Serial No. NA3-08-091R  
Docket No. 52-017  
COL/MEP

**DOMINION VIRGINIA POWER**  
**NORTH ANNA UNIT 3 COMBINED LICENSE APPLICATION**  
**RESPONSE TO REQUEST FOR ADDITIONAL INFORMATION LETTER NOS. 011,**  
**013 AND 021 (FSAR CHAPTERS 1, 5, 13, 14 AND 17)**

On July 28, 2008, the NRC requested additional information to support the review of certain portions of the North Anna Unit 3 Combined License Application (COLA). The responses to the following RAIs are provided as Enclosures 1 through 18:

NAPS COL 13.1-1-A Figure 13.1-201 Construction Organization

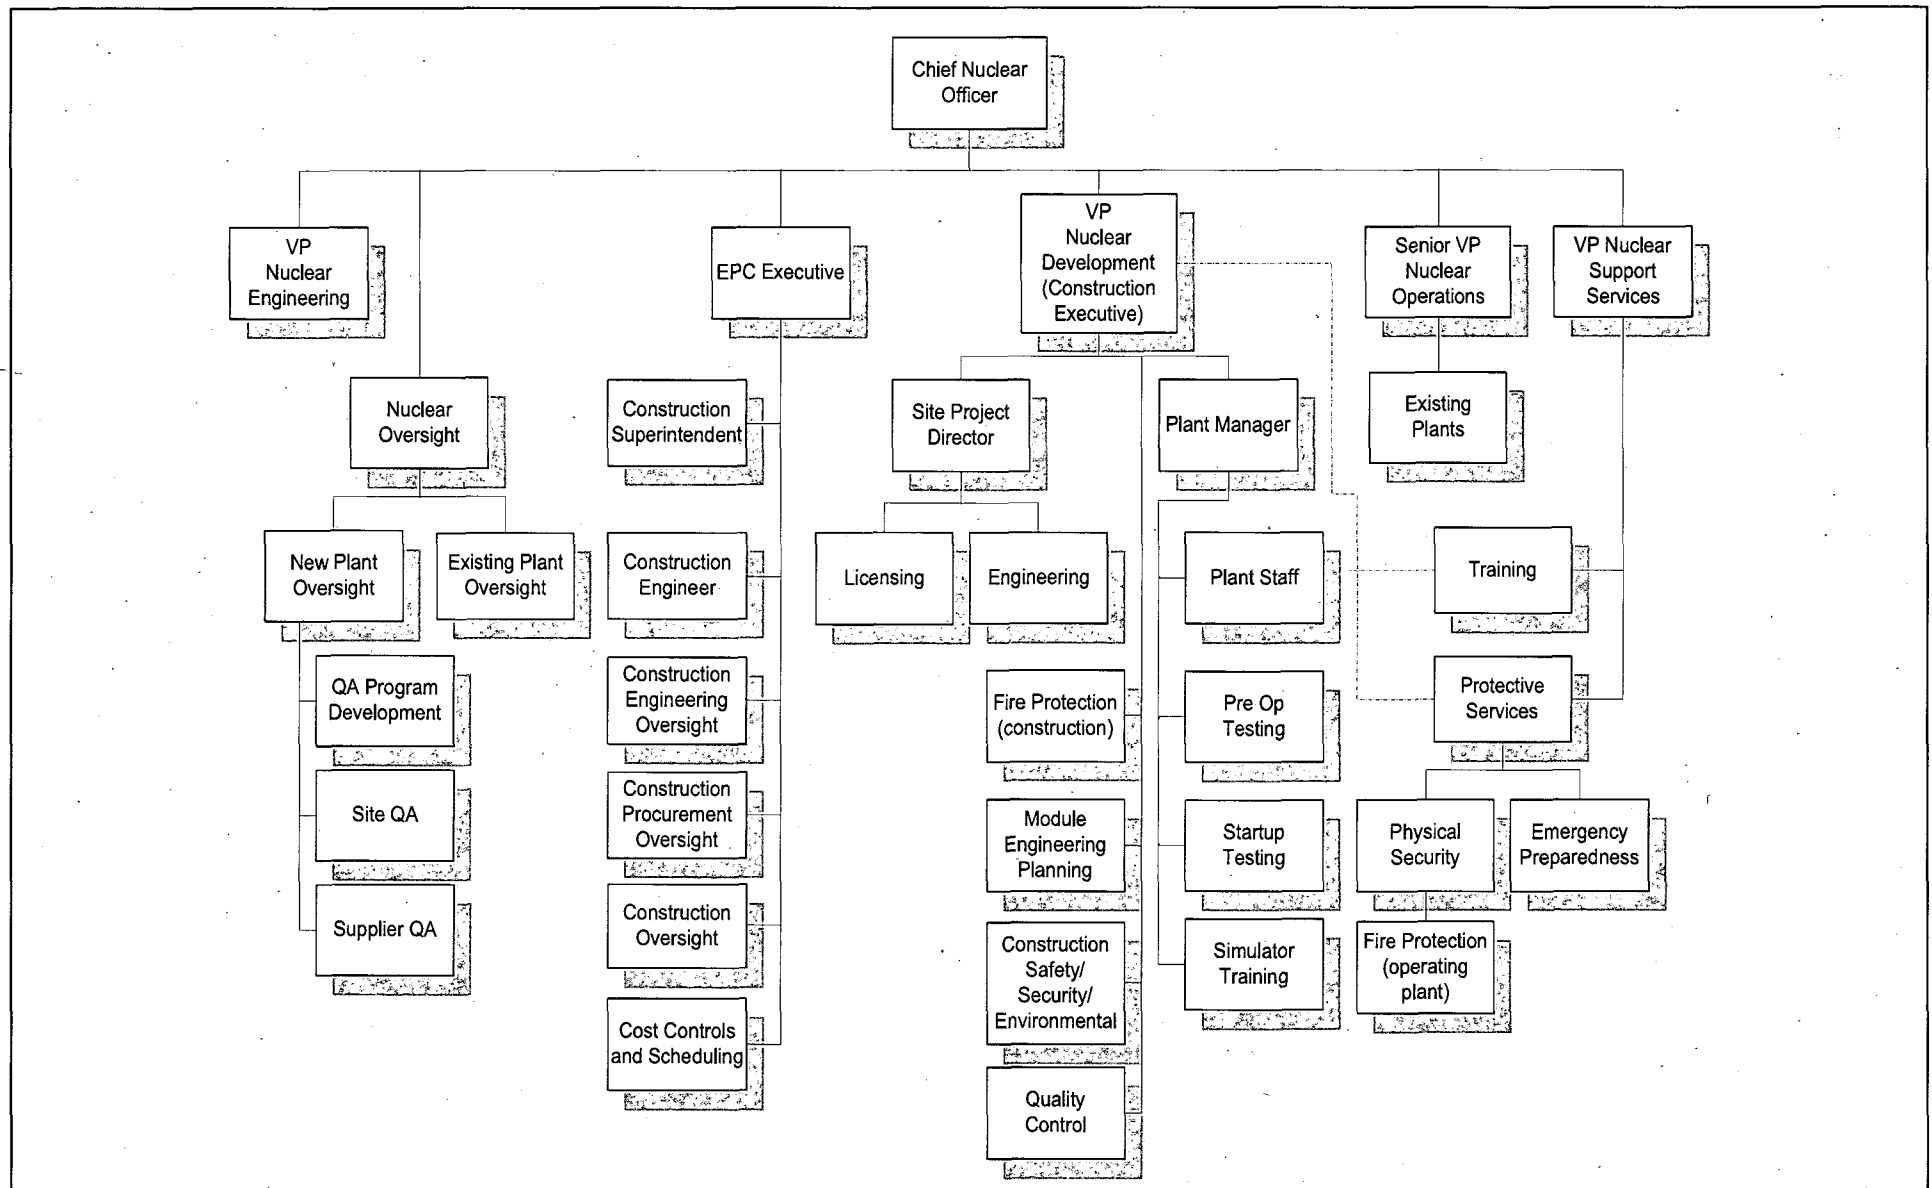
The Engineering, Procurement, and Construction (EPC) contractor will fill the roles of the NSSS vendor, the architect/engineer, and the constructor. Dominion will interface with the EPC contractor through the EPC executive. The relationship of the EPC executive with Dominion management is shown on Figure 13.1-201, Construction Organization.

**NAPS COL 13.1-1-A Figure 13.1-204 Operating Organization**

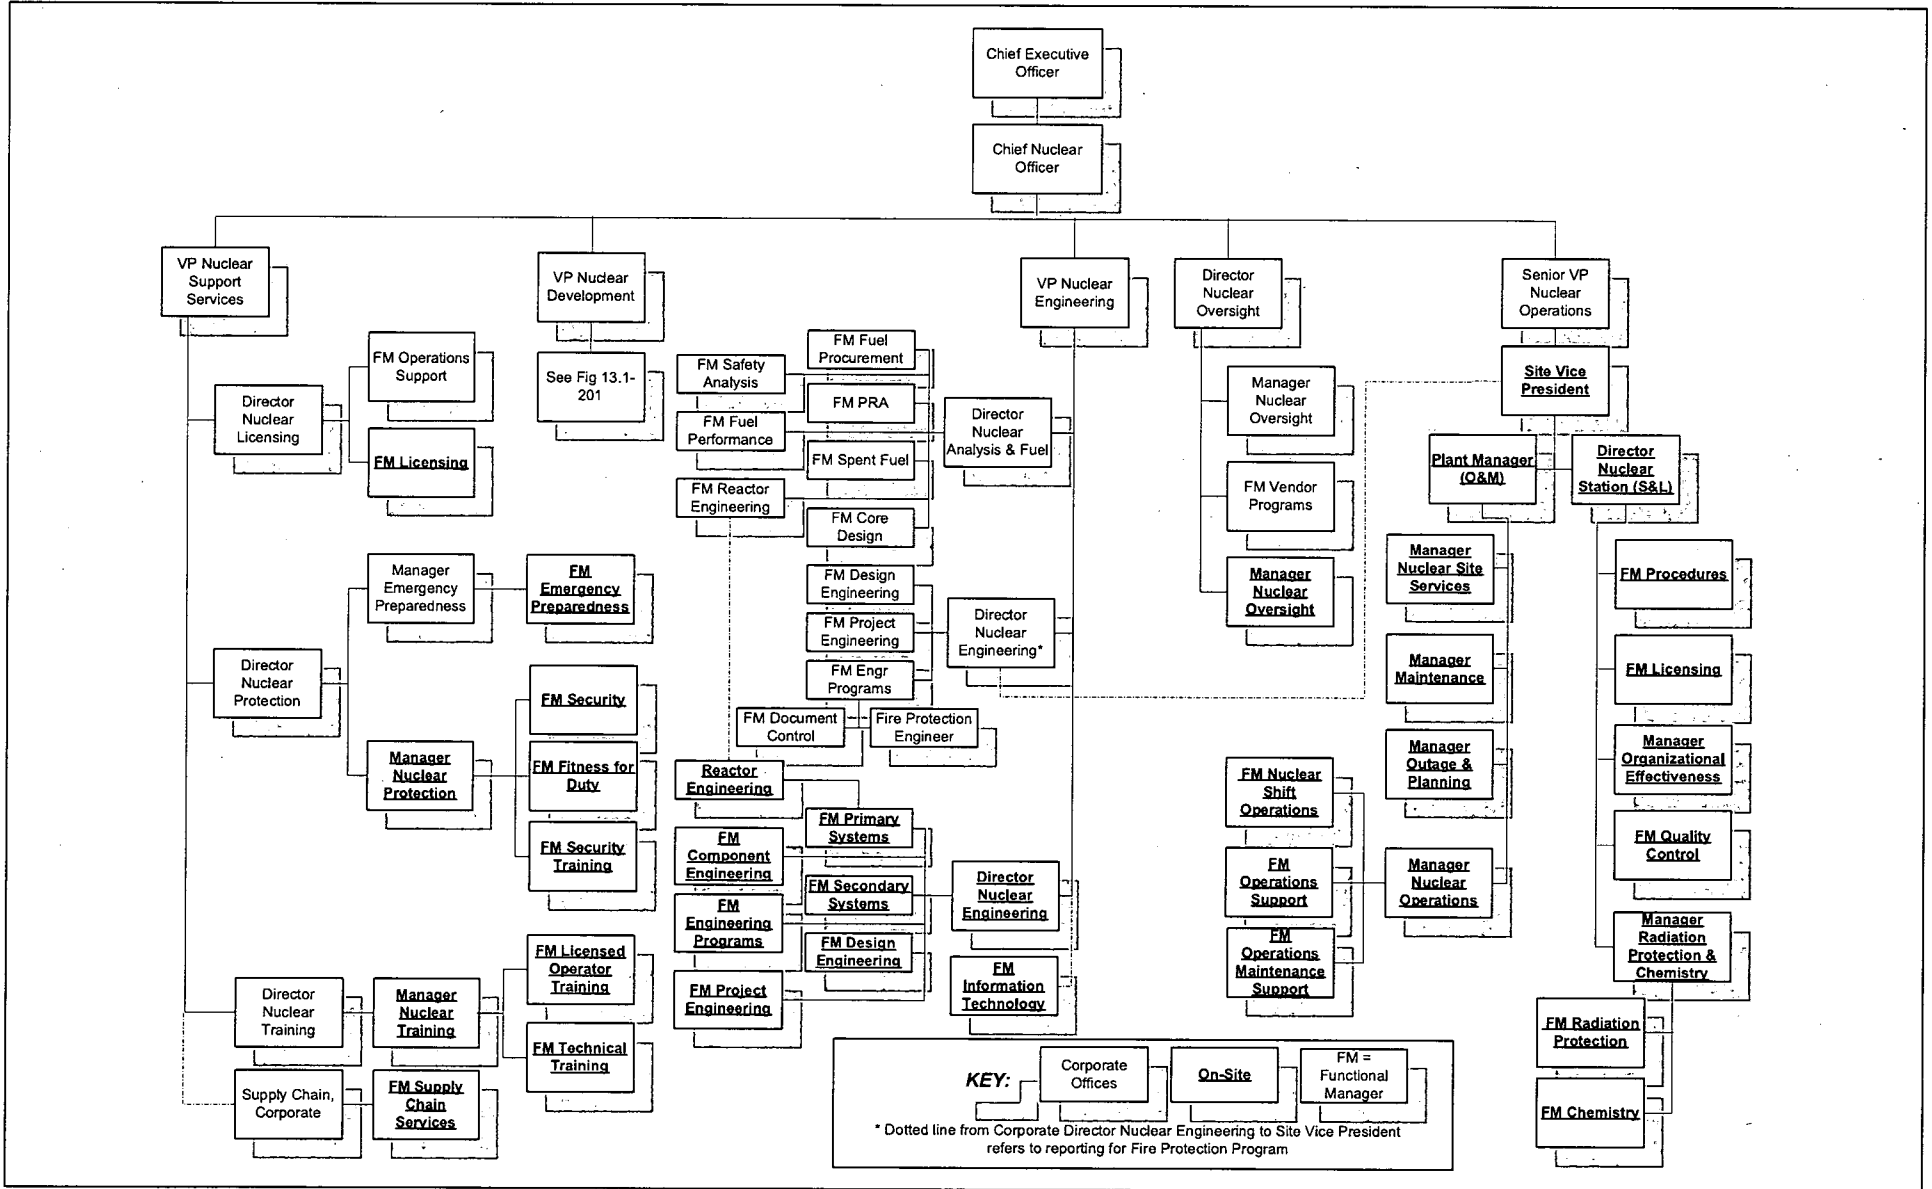
**RAI Question 13.01.01-3**

Section 13.1.1 is in error. The reference to Section 17.5 will be deleted from Section 13.1.1. Figure 13.1-204, Operating Organization, will be added to the FSAR.

FSAR Section 13.1.1 will be corrected and Figure 13.1-204 will be added as shown on the attached markup.

**NAPS COL 13.1-1-A Figure 13.1-204 Operating Organization**

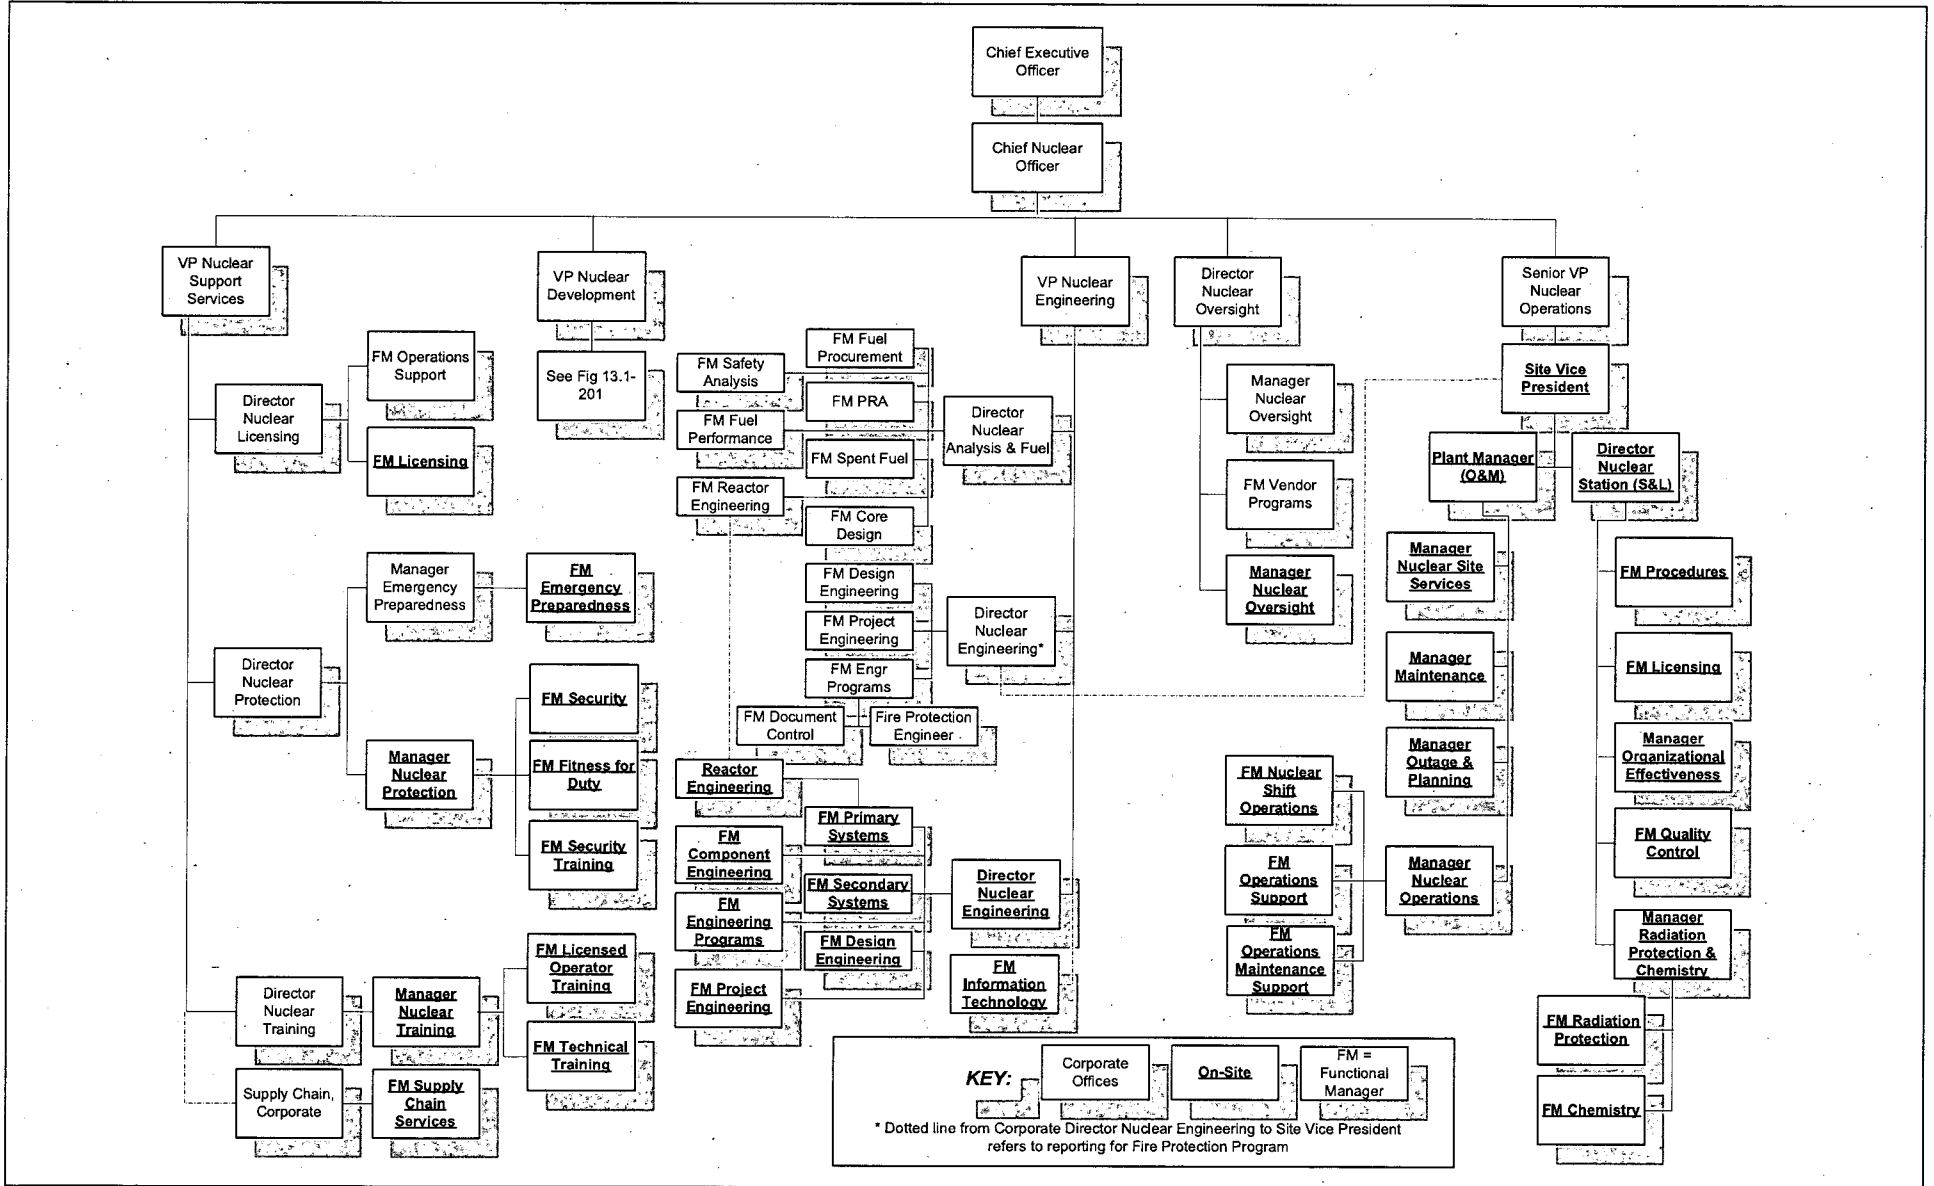
~~Section 17.5~~ Figure 13.1-204 provides a high-level ~~illustrations~~ illustration of the ~~corporate-nuclear~~ organization. More detailed charts and position descriptions, including qualification requirements and staffing numbers for corporate support staff, are maintained in corporate offices.

**NAPS COL 13.1-1-A Figure 13.1-204 Operating Organization**

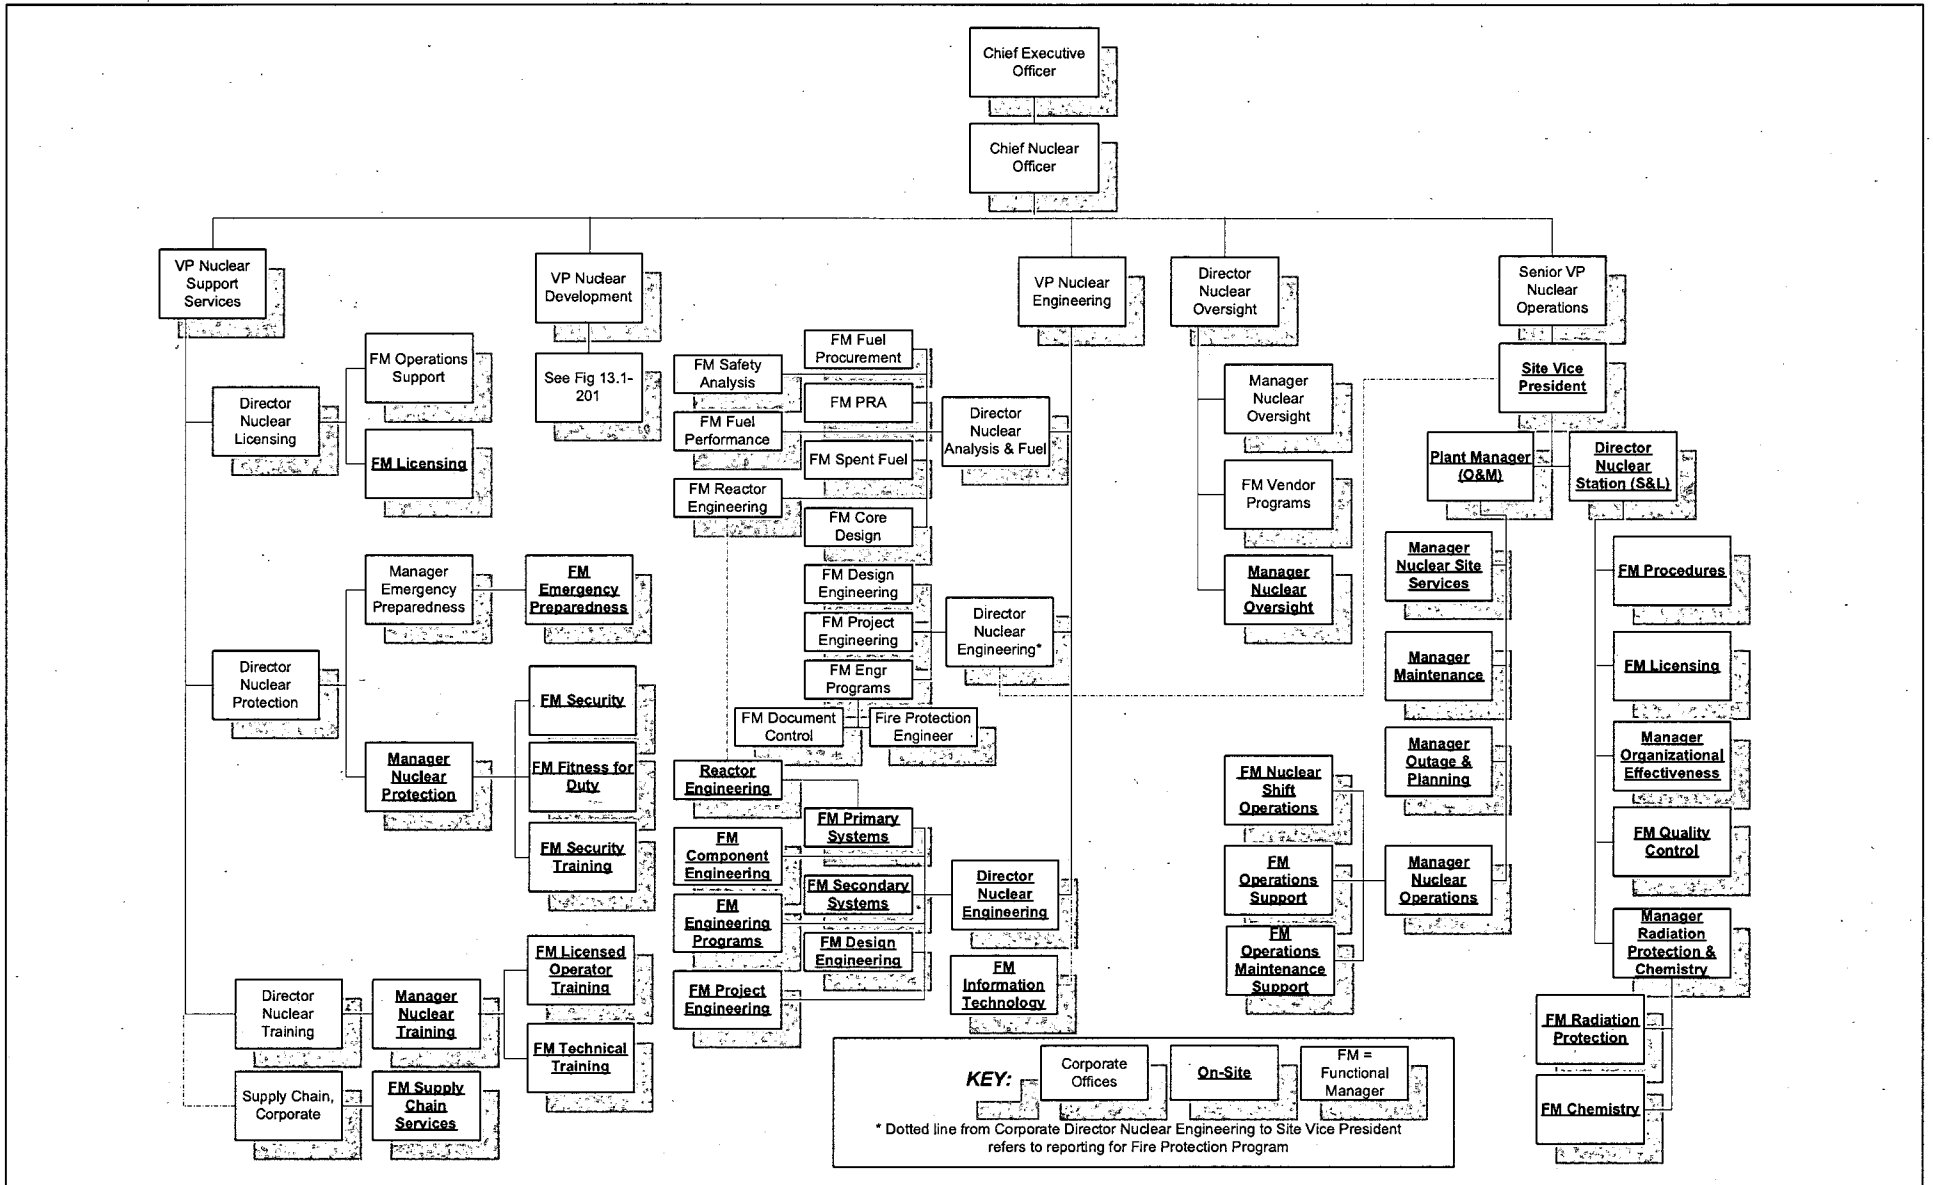
*Standard Review Plan Section 13.1.1, "Management and Technical Support Organization," section I.2.B and RG 1.206, section C.I.13.1.1.2, "Organizational Arrangement", request the applicant to provide the relationship of the nuclear-oriented part of the organization to the rest of the corporate organization. Describe where can this relationship be found in the NAPS application?*

Figure 13.1-204, Operating Organization, which shows the relationship of the nuclear-oriented part of the organization to the rest of the corporate organization, will be added to the FSAR.

The new FSAR Figure 13.1-204 will be added as shown on the attached markup.
